Hi-Fi Products
Service Bulletin

Model: CDP-C20/C30/C40/C50/C50M/C7ESD

No. 80

Subject: CD Carousel Misoperation

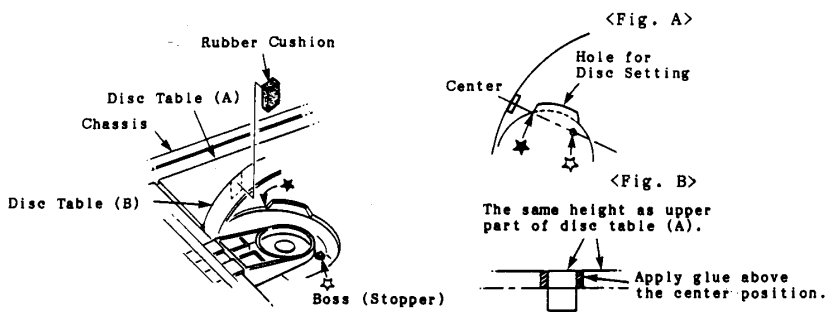
1. The fulcrum of the BU bracket is out of place.
(Supporting claw for BU bracket bends and does not hold fulcrum.)
2. The chucking pulley is broken.
3. The disc table (B) has run over the rotating stopper boss of the BU bracket.
4. The rotating stopper boss has broken during transportation, allowing the disc table to shift out of position. If the unit is turned ON in this condition, the BU bracket will come up through the hole in the disc table (B).

Solution: 1. In the case of the fulcrum being out of place, install a rubber cushion behind the supporting claw to prevent it from bending. This will ensure that the fulcrum is held firmly in place.

2. If the chucking pulley is broken, replace it with the new type of chucking pulley listed below:

3. In the case where the disc table (B) runs over the
